MS90 Audio & USB Daughter Board Block Diagram

FOXCONN		HON HAI Precision Ind. Co., Ltd. CCPBG - R&D Division
Title	Block Diagram	
Size	Document Number	Rev
Custom	MS90-1-02	1.0
Date	Friday, March 23, 2007	Sheet 2 of 10

FOXCONN		HON HAI Precision Ind. Co., Ltd.	
Title		History (1)	
Size	Document Number	Rev	
A3	MS90-1-02	1.0	
Date:	Friday, March 23, 2007	Sheet	9 of 10

FOXCONN		HON HAI Precision Ind. Co., Ltd.	
Title SUB_WOOFER AMP.		CCPBG - R&D Division	
Size	Document Number	Rev	
A3	MS90-1-02	1.0	
Date:	Friday, March 23, 2007	Sheet	8 of 10

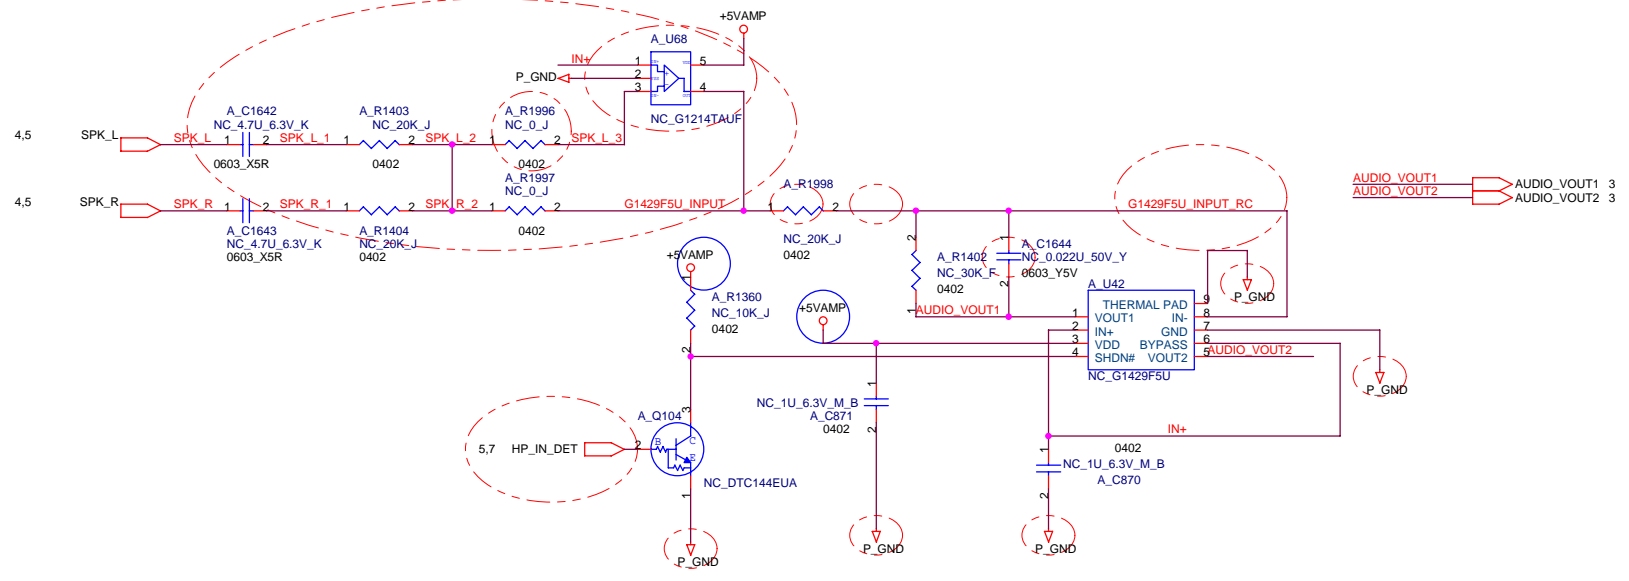
P.08 Modify Sub_Woofers Circuit

Add A_C1642,A_C1643,A_C1644,A_R1996,A_R1997,A_R1998,A_U68(NC),A_R1996(NC).

Del A_C868

P.08 A_R1996 change from 30K ohm to 0 ohm for GMT FAE Suggest.

P.08 A_U68,A_R1996 change from stuff to NC for sub_woofer circuit.
